1506 NW 61ST

DESIGN REVIEW RECOMMENDATION
NORTHWEST BOARD
AUGUST 17TH, 2015

DPD PROJECT #: 3017177
ADDRESS: 1506 NW 61ST ST
SEATTLE WA

BASEMENT UNITS:

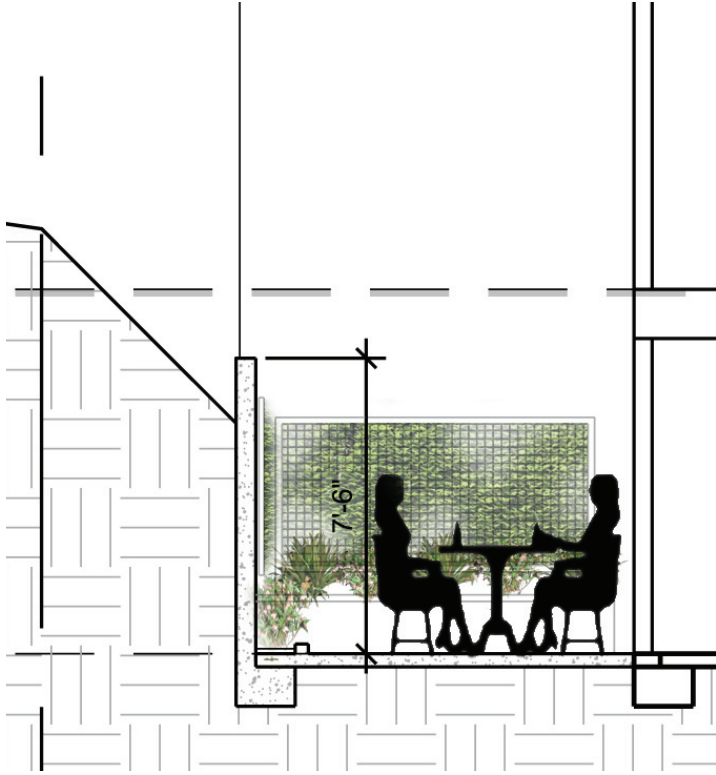
Guidance: The basement units remained troubling for members of the board , and the board would like to see studies that would better convey some of the experience inhabiting the units and the below-grade amenity space adjacent to the units.

Response: Modifications have been made and included in the proposed design to improve the amenity space and basement units' access to light and air. A sloping 5' landscape buffer has been provided from the West property line to the retaining wall of the below-grade amenity space, allowing for the maximum amount of light and air to reach the units and amenity space, as well as minimizing the height of the retaining wall. Greenery has been provided in planters and screens to allow for vines will soften the impact of the wall, as well as separate each unit's individual amenity space. Further model images are provided as part of this packet. See page 22.

ENTRY:

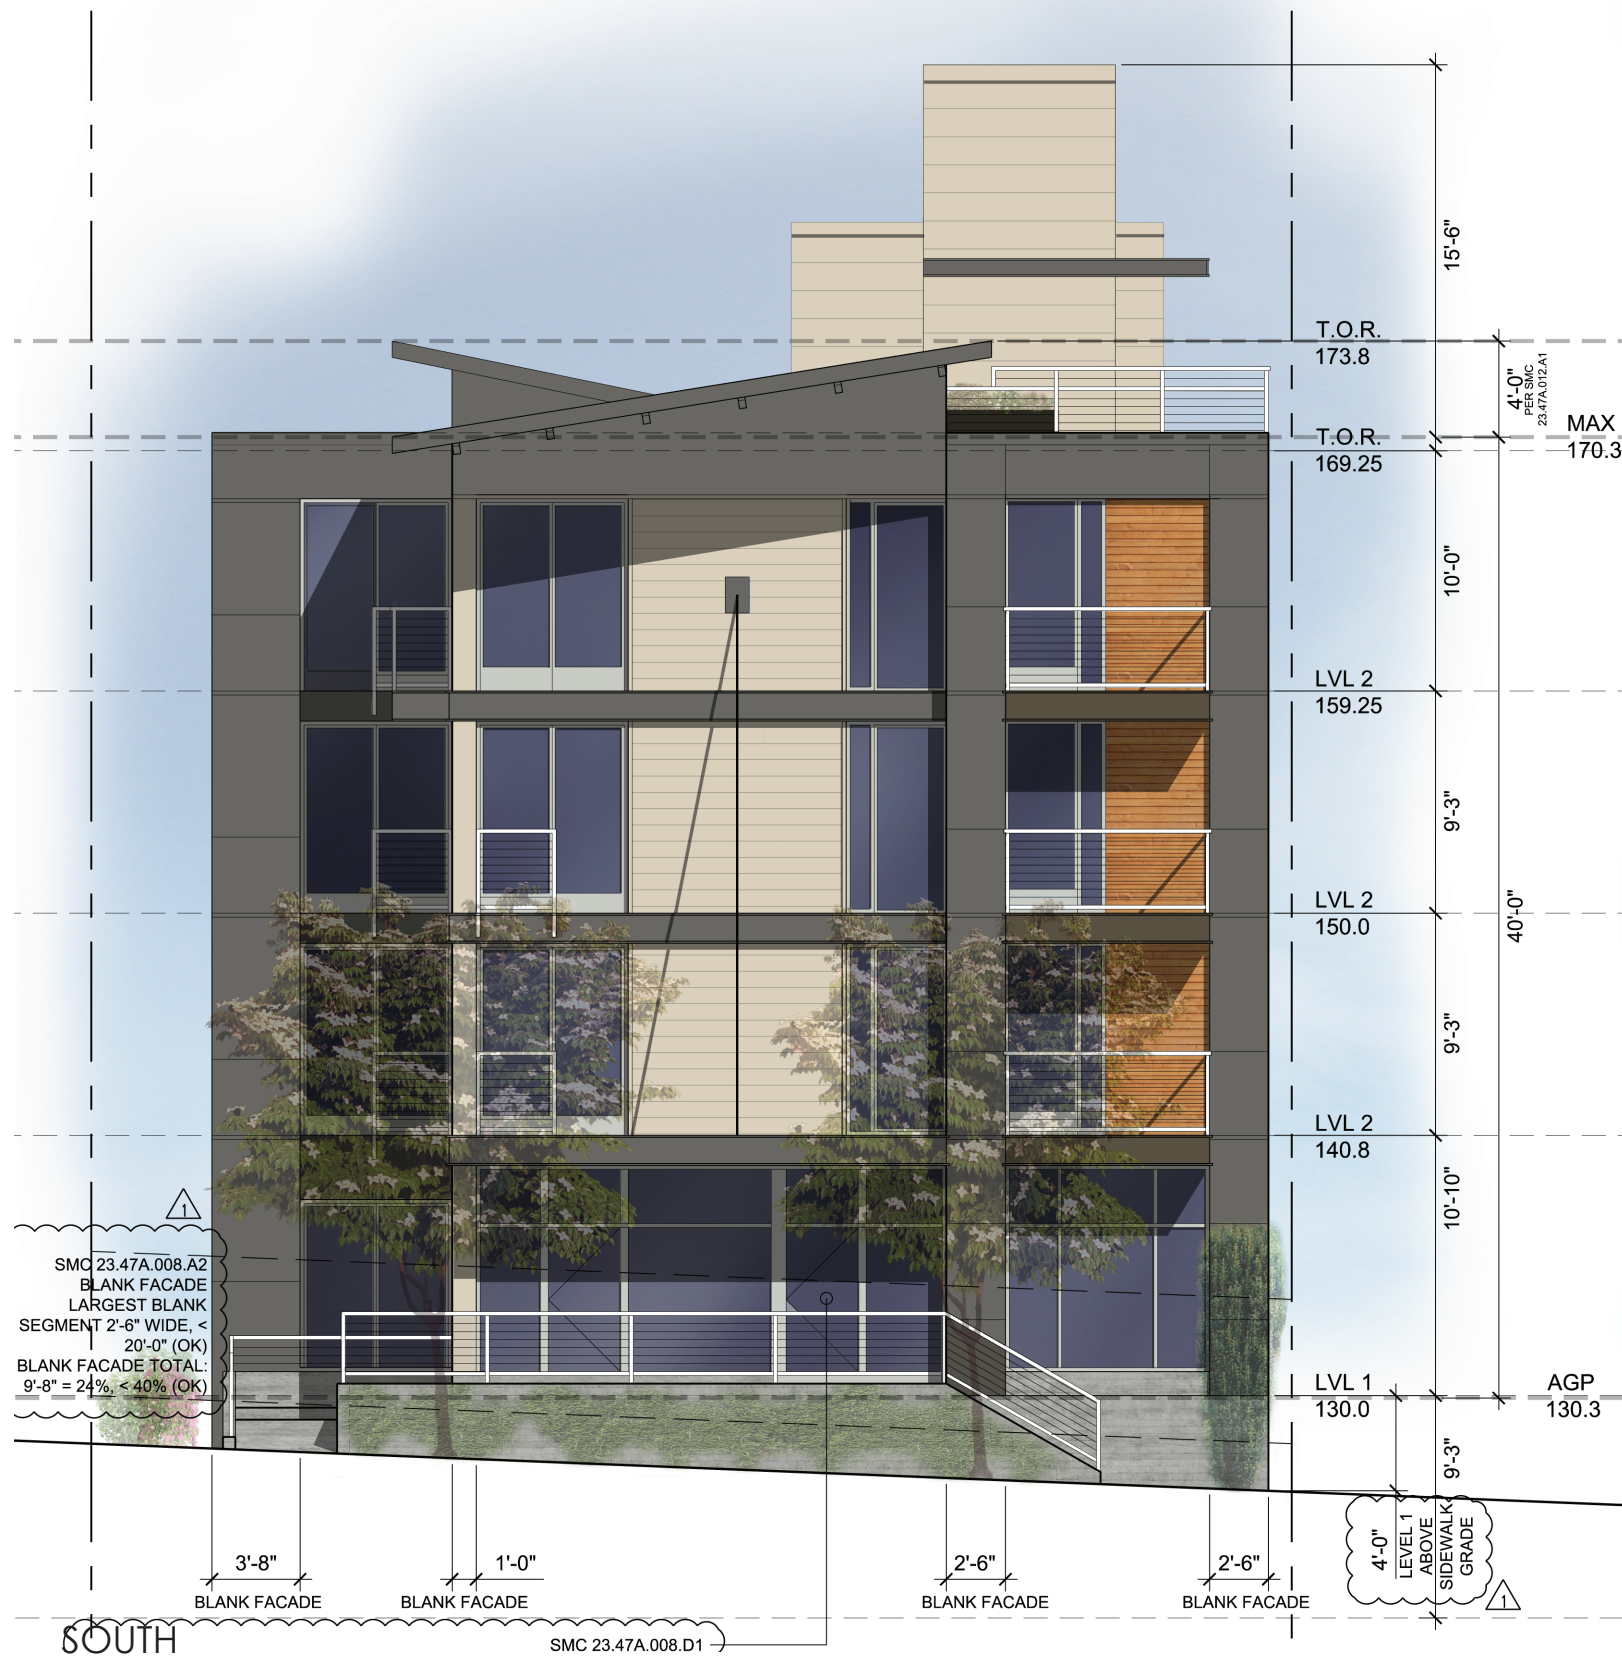
Guidance: The board would like to see more analysis and details of how the entry sequence works and how the interface of building entry and landscaping and sidewalk will be laid out and layered.

Response: The entry sequence is a direct response to the challenge of reconciling the topography and accessibility of the site. A switchback ramp is located at the high (West) end of the site to limit the amount of ramp required and to maximize the amount of landscaping / pervious area possible. On the East side of the site a stair is located to provide access in close proximity to 15th Ave NW, the primary arterial in the area. The retaining wall supported patio along the back of the sidewalk is a reflection of the retaining or site wall condition that is common along the North side of NW 61st Street. The elevated entry also provides a sense of security for the entry while still allowing for a direct connection with the public right of way.

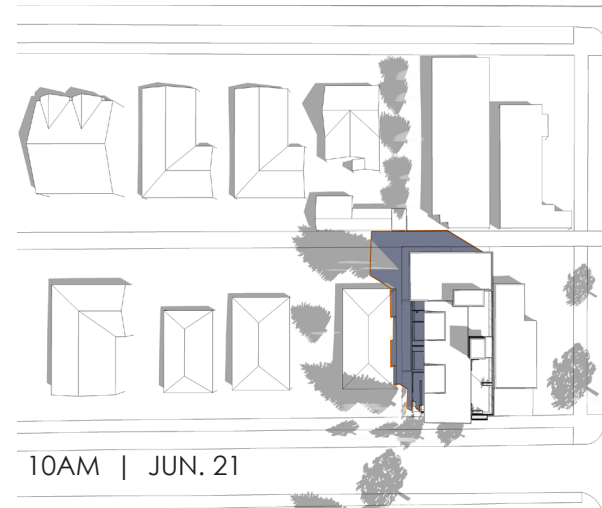
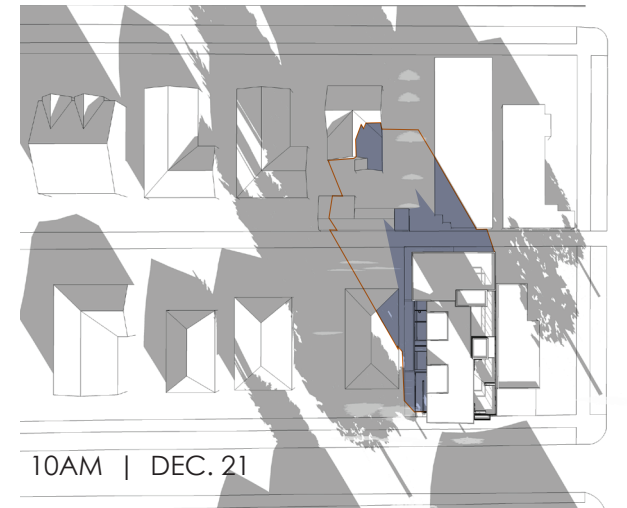
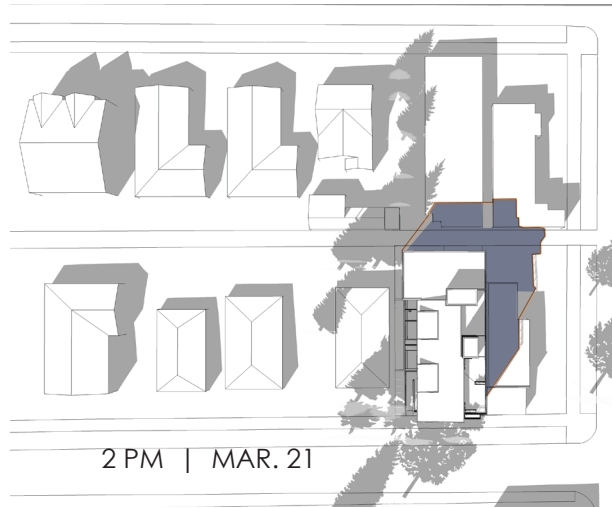
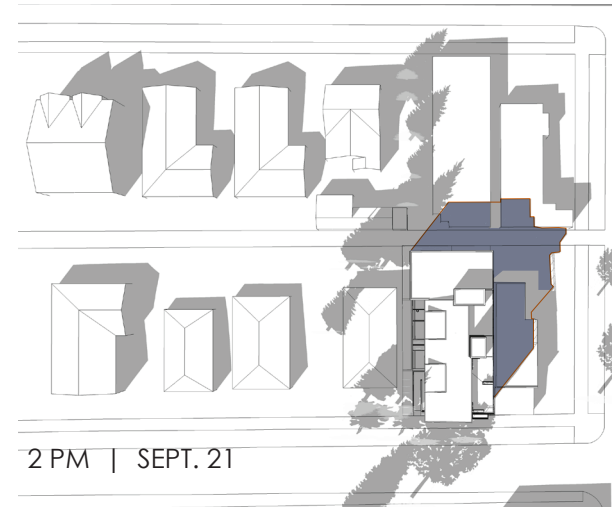
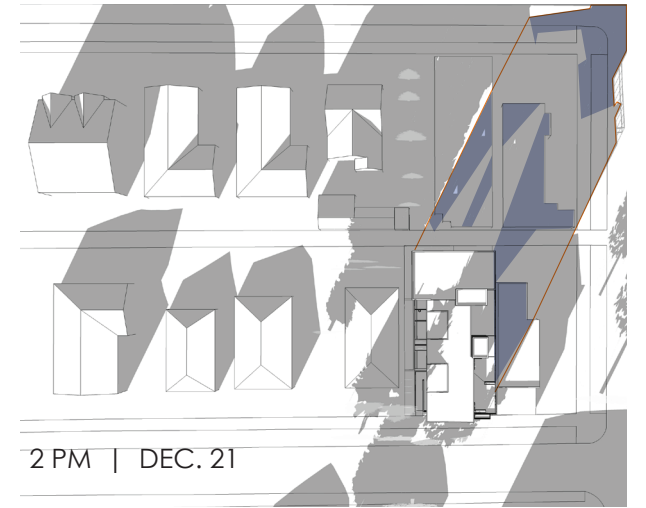
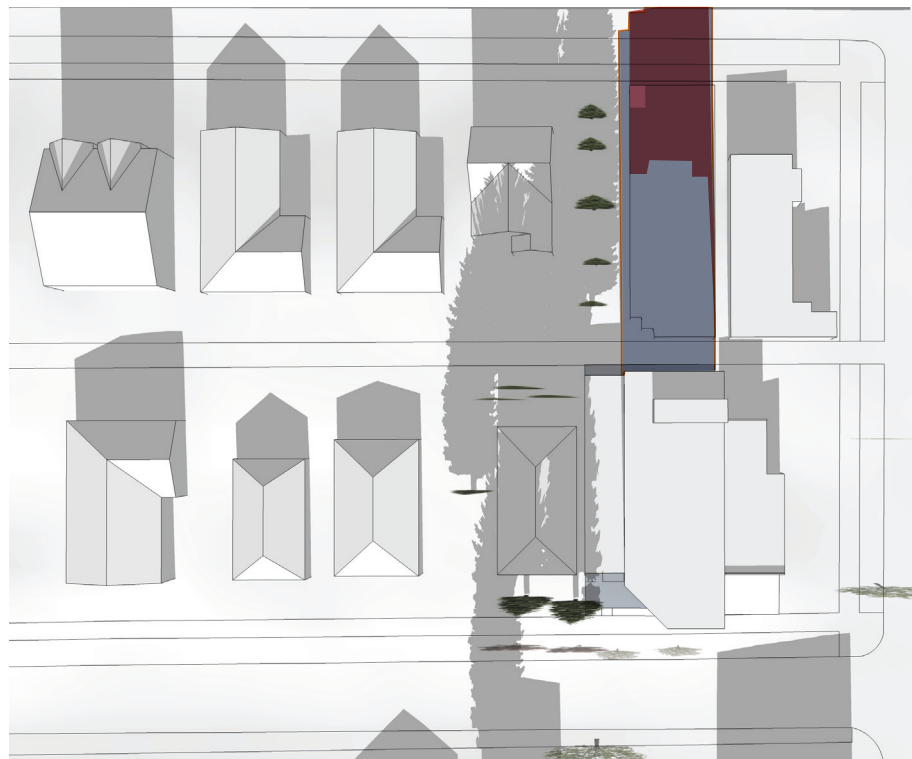
- C) The board would like to see a more comprehensive study of the shadows from the proposed structure, at a broader scope of times, as these impact the structures and yards of the neighbors to the North across the alley.

- C) A more comprehensive shadow study is provided as part of this packet. The conclusion of the shadow analysis is that the impact of shadows on the properties to the North is mitigated by several factors, such as the location of the stair and elevator towers on the proposed design, the existing large evergreen trees that currently shade the properties, and the lack of open space and fenestration on the South facing facades of the adjacent properties to the North.

The shadow impact of the proposed project is mitigated by several factors.

- 1) The project's rooftop features (elevator penthouse, stair penthouse, rooftop deck) have been located away from the North property line.
- 2) Large trees located on the adjacent property (01 below) already shade the adjacent properties to the North in most conditions. Blue areas in the shadows studies indicate portions of shadow created only by the new building.
- 3) The property to the Northwest (02 below) has a garage / utility building along their South property line. This building and the large trees on the adjacent property already shade much of their open space in many conditions.
- 4) The properties to the North and Northeast have no open space to shade, and little or no fenestration on their South facades (03 & 04 below) and the impact of shading on their South facades and residents will be minimal.
